**Thorndike Place floodplain estimates**

To: Zoning Board of Appeals

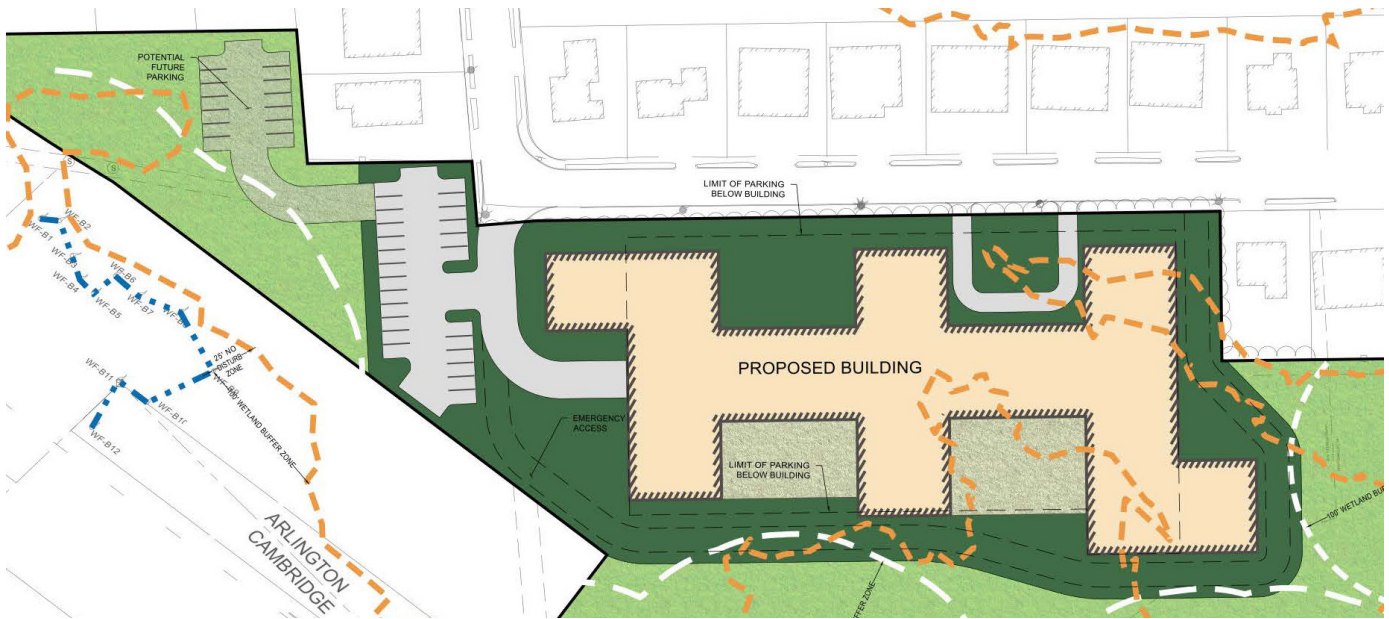
In reviewing the September plans for Thorndike Place I noticed that they differ significantly from the 100 year floodplain boundaries as defined by FEMA. The official FEMA floodplain boundaries are more extensive than the limits as shown on the Thorndike Place survey. These differences are particularly significant in the location where the apartment building is set. It was declared at the hearing that only 17,237 sf of floodplain would be filled in. A rough estimate suggests that the actual figure is more than 50,000 sf.

Attached are drawings that illustrate these differences. The source of the FEMA map is the Arlington GIS database.

I do not recall this discrepancy being explained at the Oct 1 hearing in which these latest plans were presented.

**Thorndike floodplain comparison.pdf**

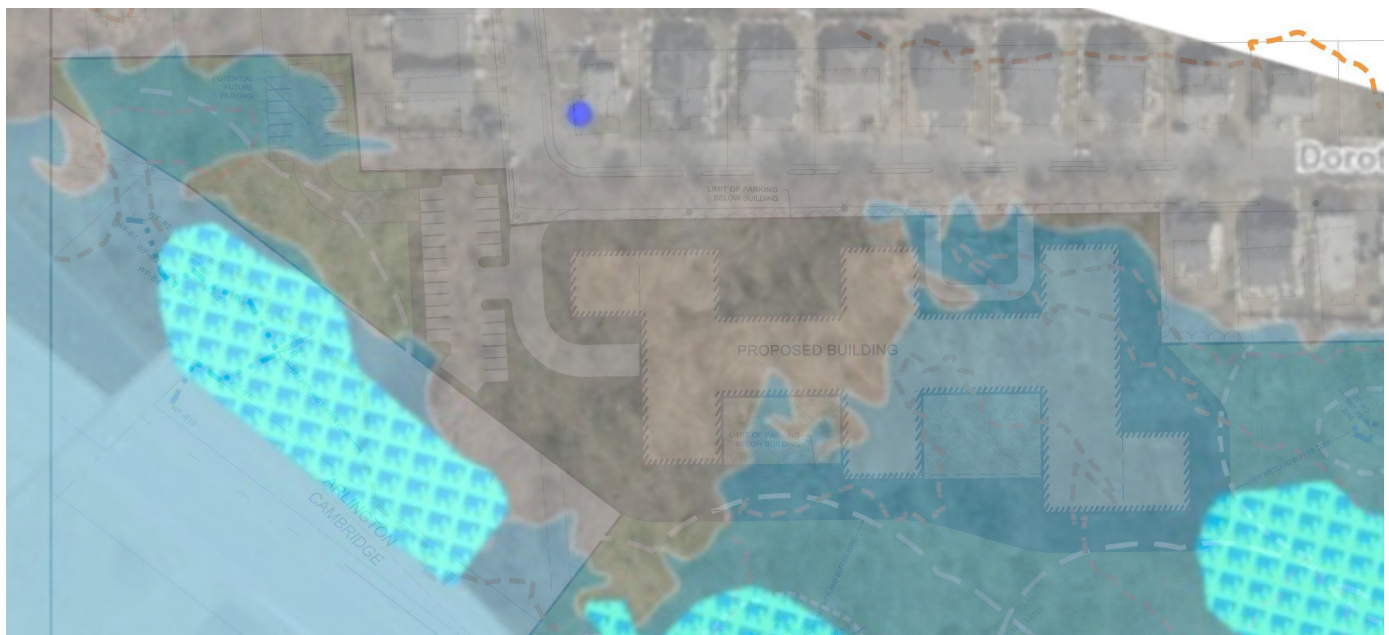
# Floodplain not included in Thorndike Survey

Filled in Floodplain >50,000 sf

Sept 28 Plan claims only 17,237 sf
